Technical Service Information

FORD 4R70W /4R70E/4R75E 2003-UP

NO SPEEDOMETER READING OR SPEEDOMETER READING SLOW

Figure 4

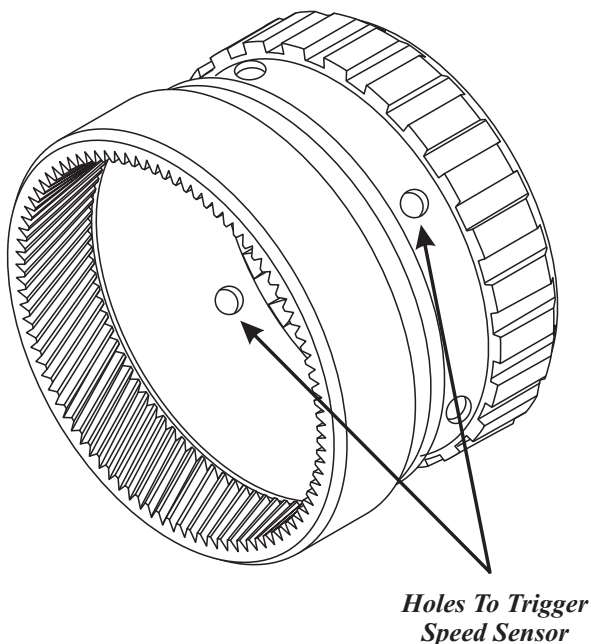
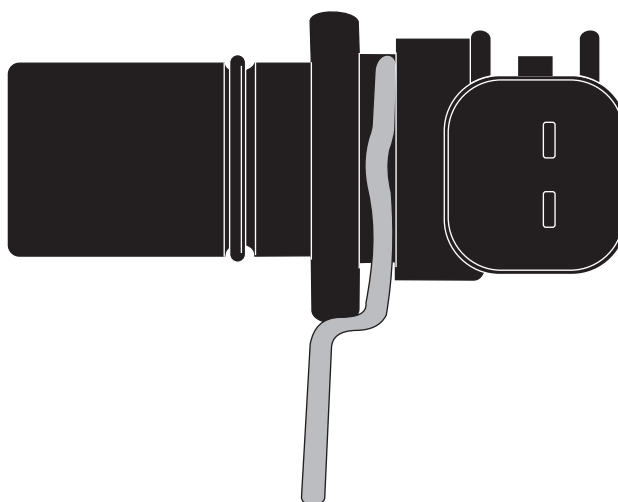
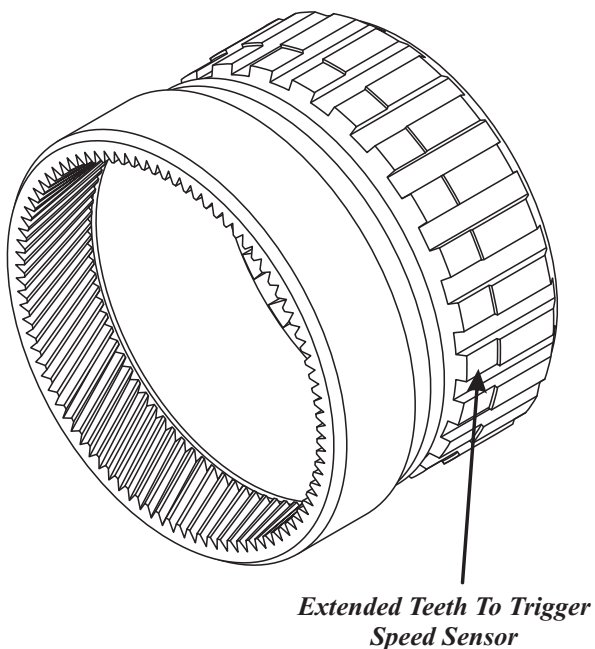
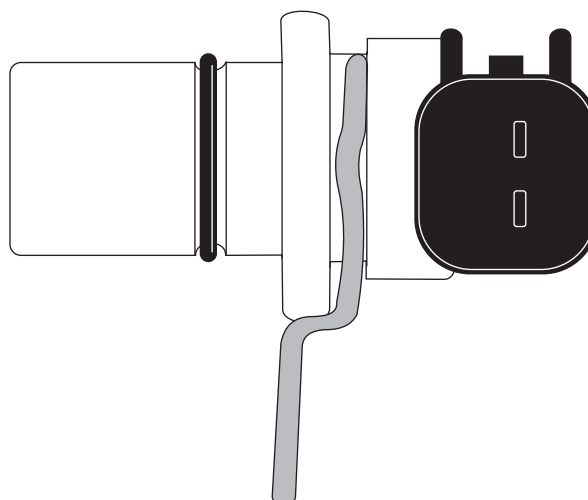
CAUSE: Beginning at the start of production for the 2004 model year, this family of transmissions is manufactured with extended parking lugs on the ring gear to trigger the output speed sensor, instead of the previous design with holes in the ring gear, which also required a strategy change in the PCM. If either a transmission earlier than 2004, or the use of 2003 or earlier ring gear is installed in a 2004-up vehicle, the PCM will not be able to correctly calculate vehicle speed, and will result in either no speedometer reading, or a slow speedometer reading. DTC's P0720-P0722 may be set. The 2004-up Rear Ring that has the extended park lugs utilizes the Output Shaft Speed Sensor with the white body, and a black connector (See Figure 5). The 2003-earlier units had the Rear ring gear with the holes, and utilizes the all black Output Shaft Speed Sensor, which is .083 inches longer than the 2004-up Output Shaft Speed Sensor (See Figure 4).

CORRECTION: Make sure that either during overhaul, or transmission exchange, the correct Rear Ring Gear, and Output Shaft Speed Sensor is used. (See Figures 4 and 5).
